MIL-F-50983B (AR)
AMENDMENT 9
19 October 1984
SUPERSEDING
AMENDMENT 8
22 February 1984

MILITARY SPECIFICATION

FUZE, MT, SQ, M577
LOADING, ASSEMBLING, PACKING AND METAL PARTS
FUZE, MT, SQ, M582
METAL PARTS

This amendment forms a part of Military Specification MIL-F-50983B (AR), dated 30 June 1980, and is approved for use by the US Army Armament, Munitions and Chemical Command and is available for use by all Departments and Agencies of the Department of Defense.

FIGURE 1

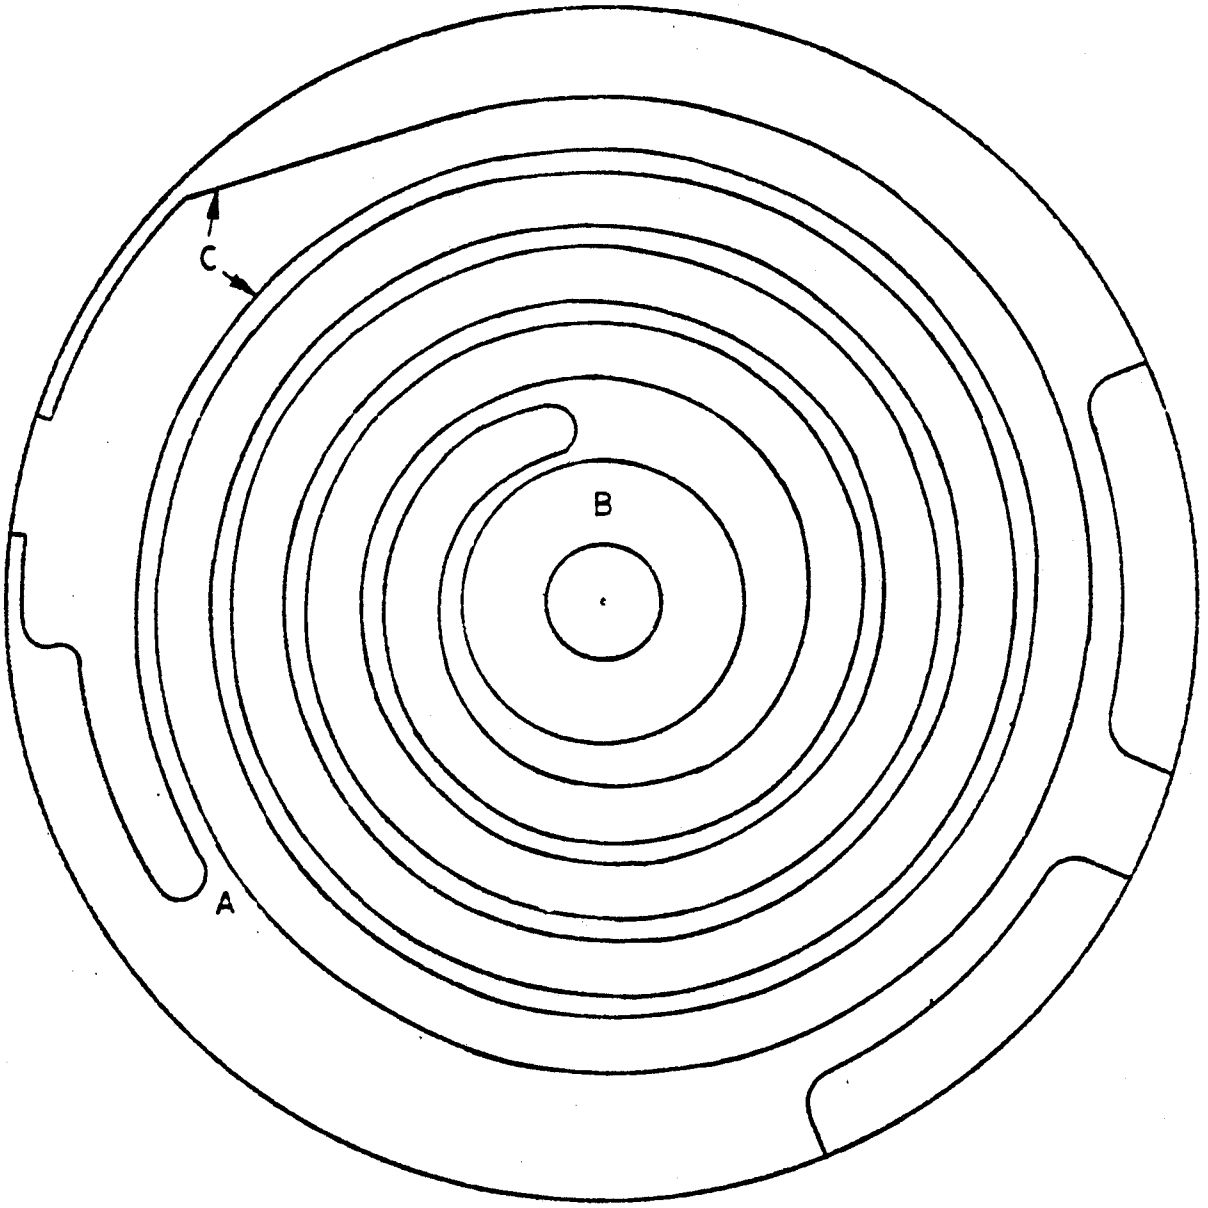
3.17.2: Delete "Figures 5 and 6" and substitute "Figures 1 and 2".

Add Figures 1 and 2 attached.

FEATURE	MAX SINGLE PORE SIZE IN ANY DIRECTION (INCHES)	MIN REMAINING IDEAL SURFACE (%)
HOLE A	.02	90
HOLE B	.02	90
HOLE C	.10	80
HOLE D	.02	90
HOLE E	.10	80
SURFACE F	.02	80
SURFACE G	.02	80
SURFACE H	.02	80
